ADC3-HJL-ACD-ZZ-DR-A-P2015 Revision (P01)

PROJECT
ADAMSTOWN STATION BLOCKS ACD

DRAWING
BLOCK D ELEVATIONS

Red dash line indicates extent of amendments to address RFI 0723 dated 08 JUNE 2022

1 Block D Courtyard Elevation East
1 : 200

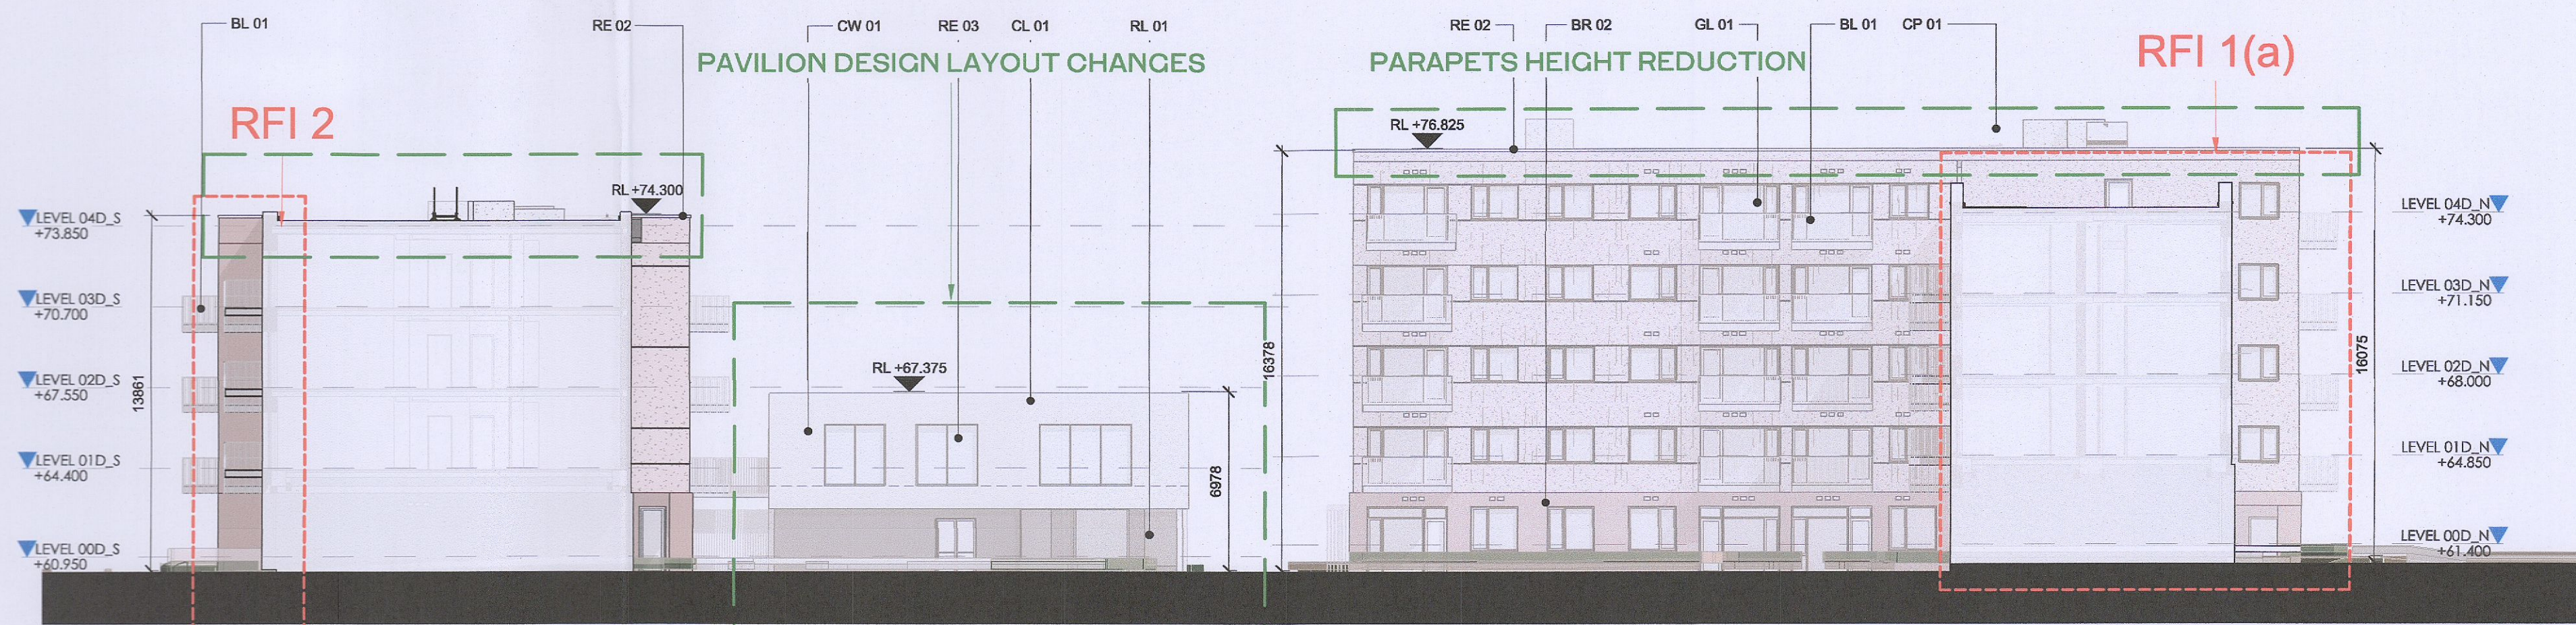
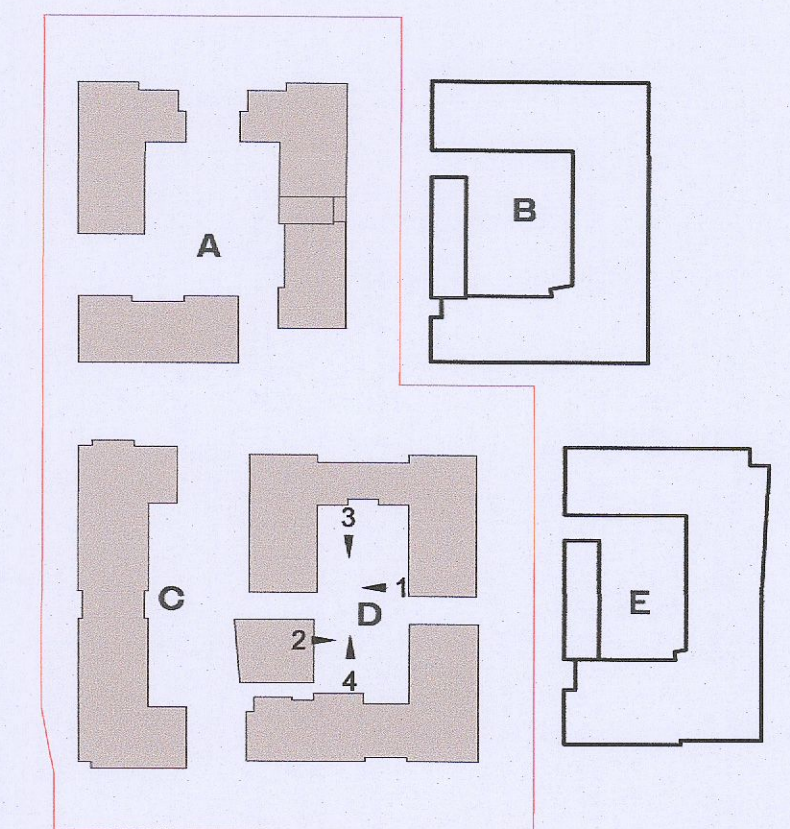
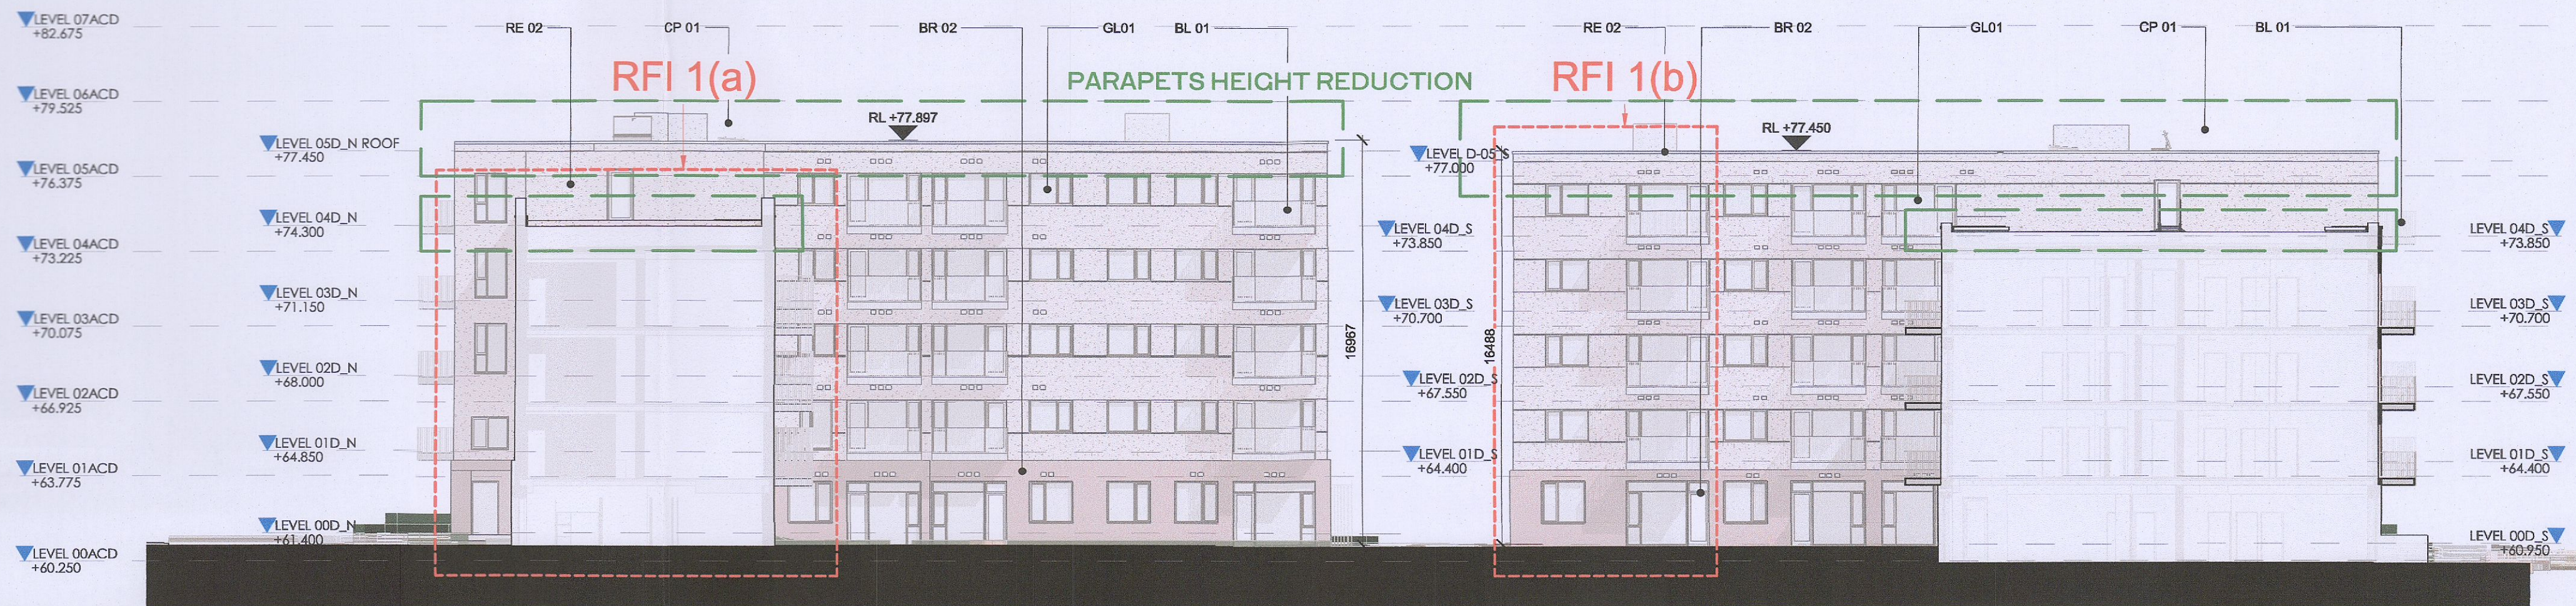
RFI 1(a)

Block D North - Changes to Core entrance hall facing Great Western Way updated to accommodate new apartment type T.301.D revised apartment type T.102.D

2 Block D Courtyard Elevation West
1 : 200

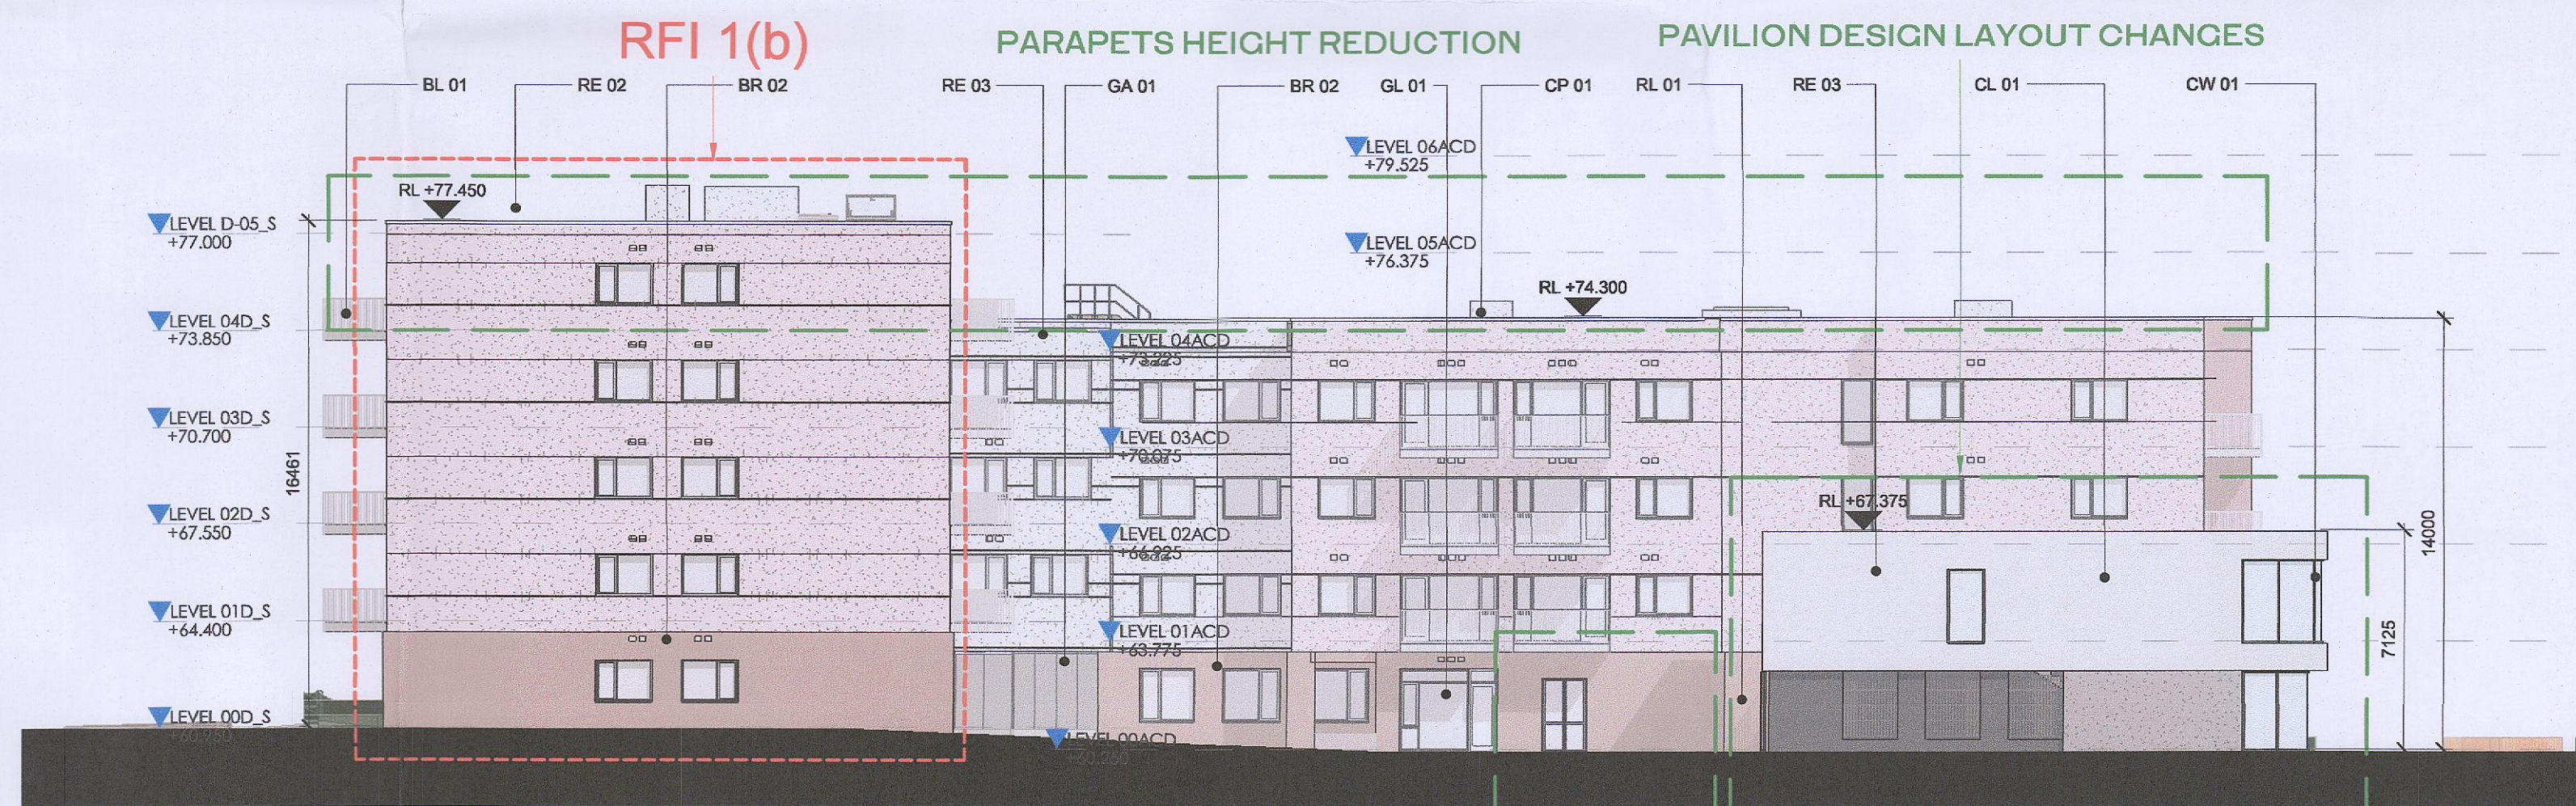
RFI 1(b)

Block D South - Changes to apartment type T.201.D and T.202.D to overcome privacy/overlooking issues

3 Block D South - Northern Courtyard Elevation
1 : 200

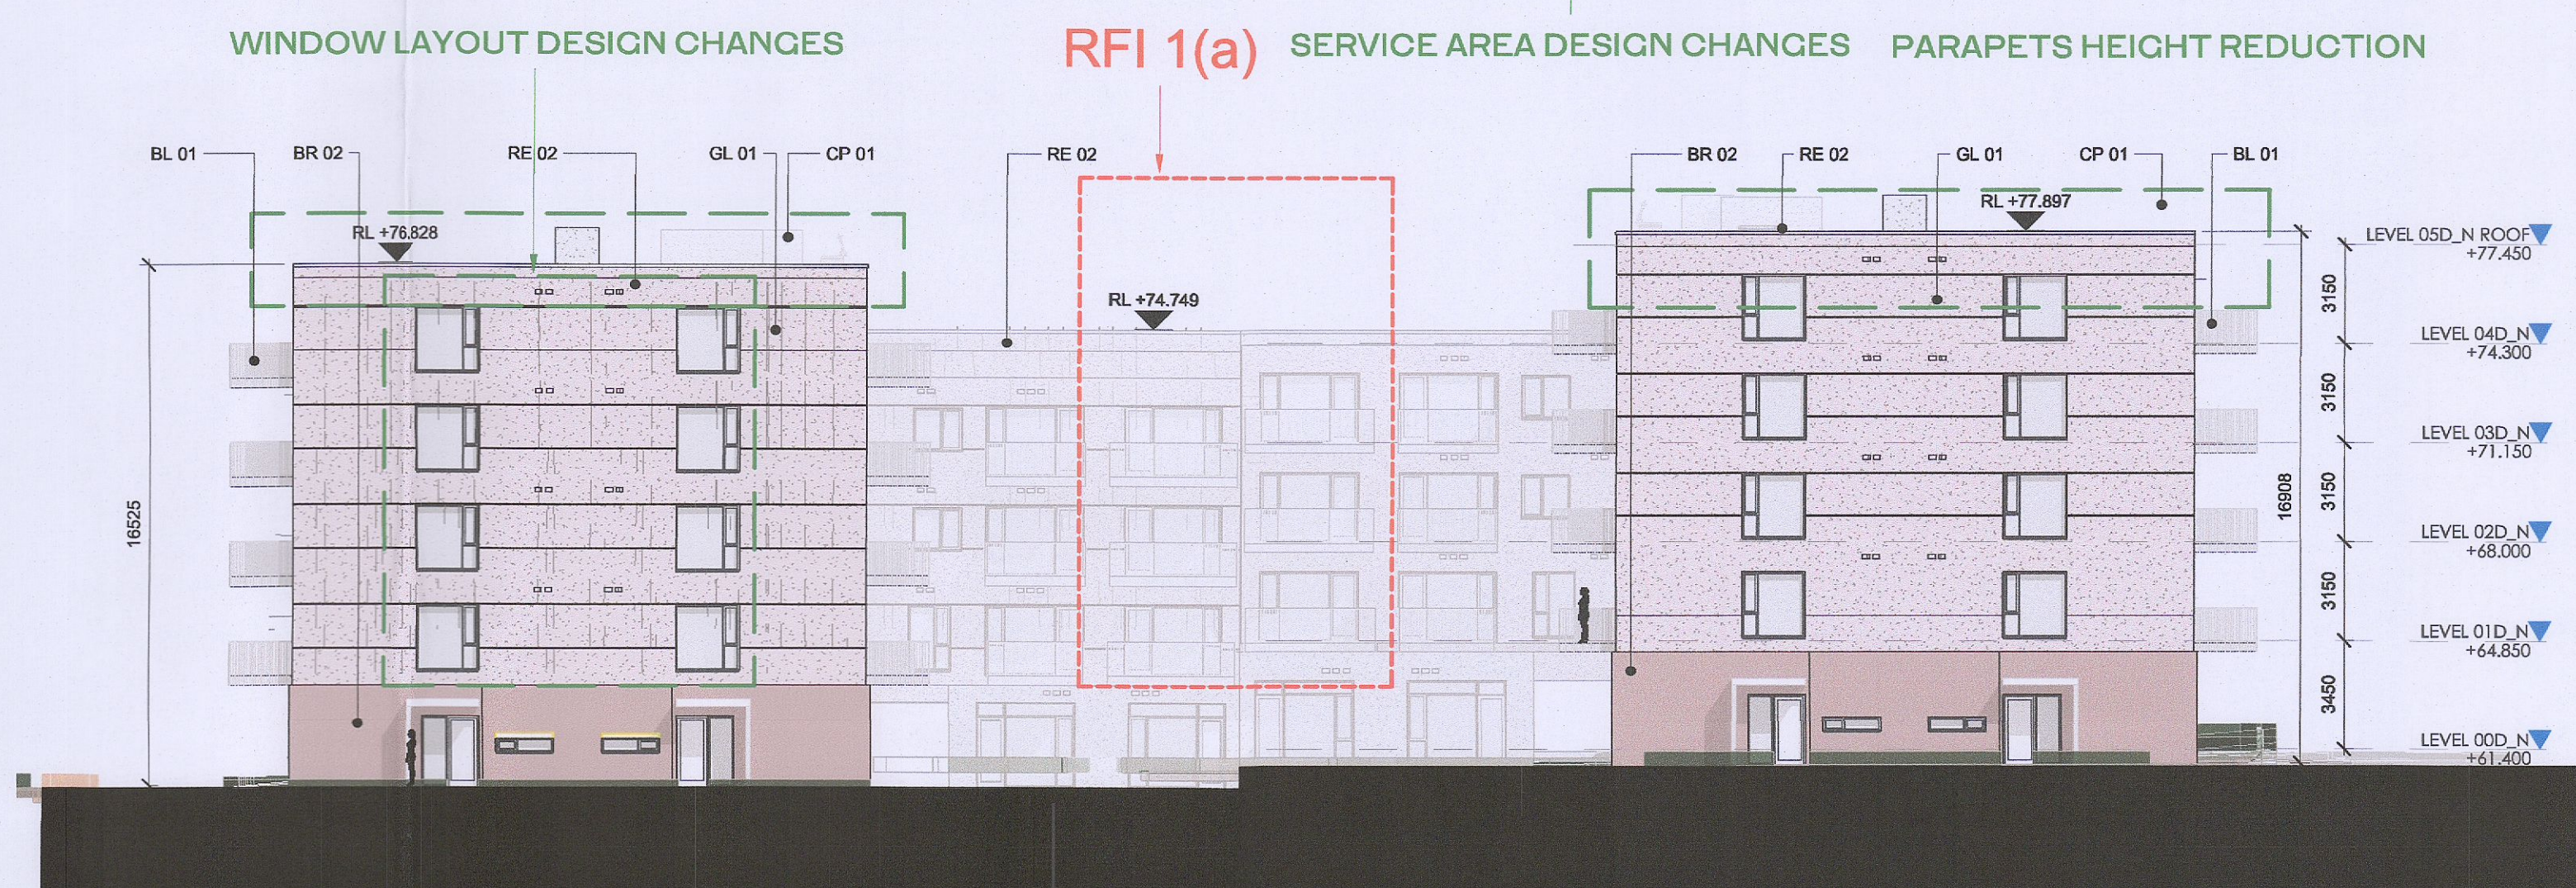
RFI 2

Block D South - Changes to facade material to brick on the upper floor levels
